Subject: Highways response to planning application

Re Planning Application DC/25/2079 – Use of Land for the Stationing of 4 no. Static Caravans (Gypsy and Traveller Residential Purposes) Cotlands Paddock, Cowfold.

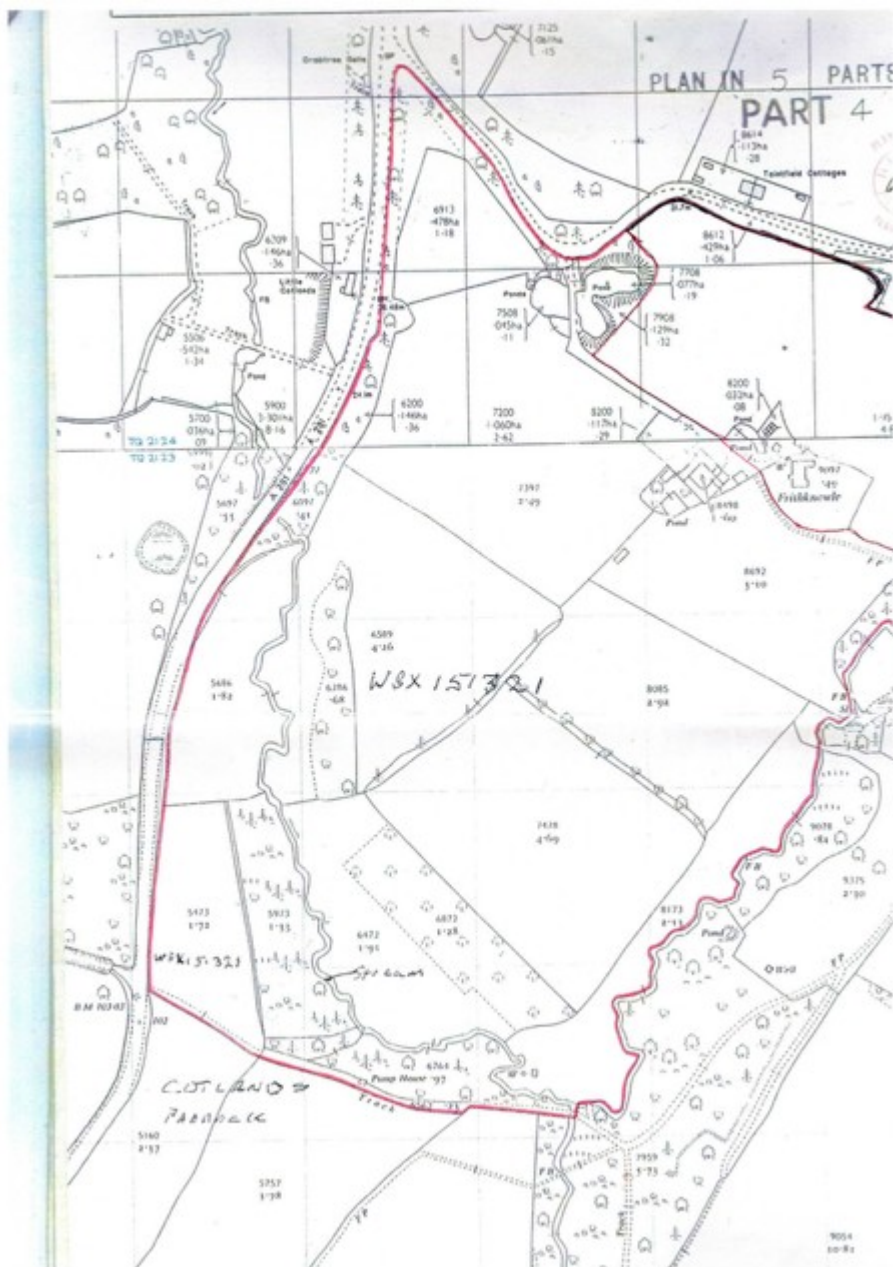
If you are driving north from Cowfold there is no line of site to see a large caravan stopped in the road waiting to turn right into the field. This will cause cars to suddenly brake on this blind bend.

Vehicles coming from north cannot see proposed access till almost on it due to rise in road.

Vehicles leaving proposed access (Inc large touring caravans) cannot see to the right.
It will greatly increase the number of vehicles using this dangerous bit of road.

There is NO safe access or egress into/out of the site. Current agricultural access was only designed for infrequent access... not this number of vehicles.

Transport Visibility Splay

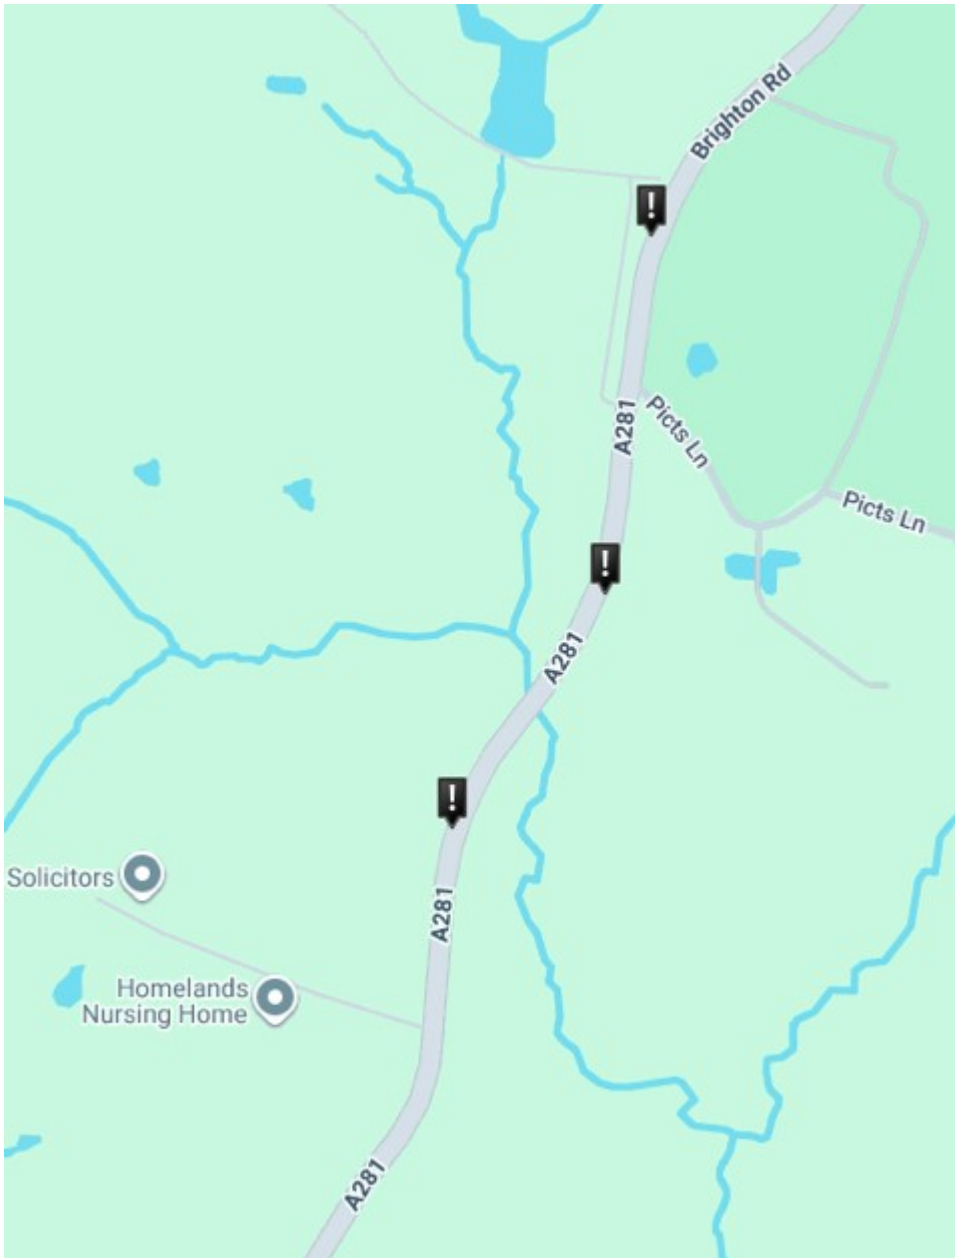
The required lengths of visibility splays are based on the speed of traffic, and for traffic speeds of 60mph the visibility splay is 215m. The plans below show the extent of a 215m visibility splay at the access. **The land registry plans confirm that the visibility splays go through third party land and are severely restricted by trees, vegetation or banking. The third party owner has stated in writing to you that he will not let his trees/vegetation be cut.**

The achievable forward visibility for vehicles travelling northbound has been measured as being less than 80m. This distance is appropriate for traffic speeds of around 35mph or less and is therefore not suitable for the higher speed of traffic on this 60mph road.

It should also be noted that the views in the photos show winter vegetation. When the vegetation is in leaf it will further obscure views along the highway with no ability to see through the bare branches.
